PA1130A SUPERSEDES PA1130

INDUSTRIE SALERI ITALO

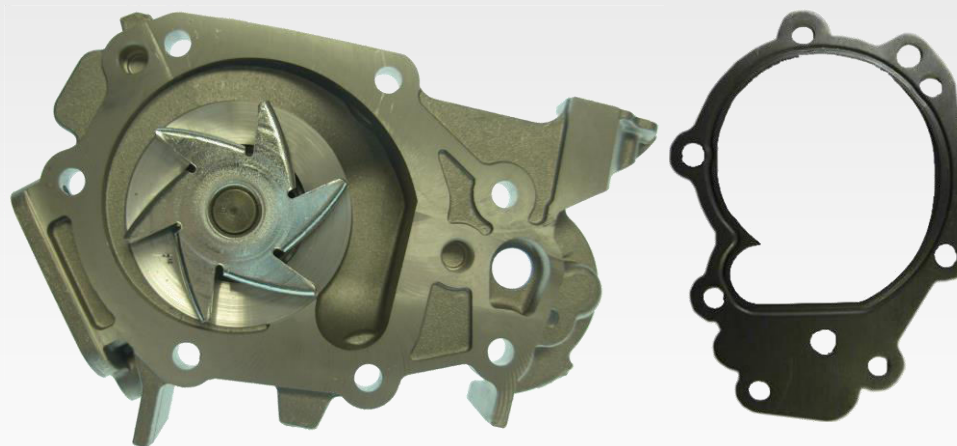
In conformity to the OE behaviour, Saleri reference PA1130 has been updated through the introduction of a metal rubber gasket, in order to grant a better tightness during the fitting phase on the engine. Therefore the use of sealant is no longer needed. The new price is indicated in the order confirmation.
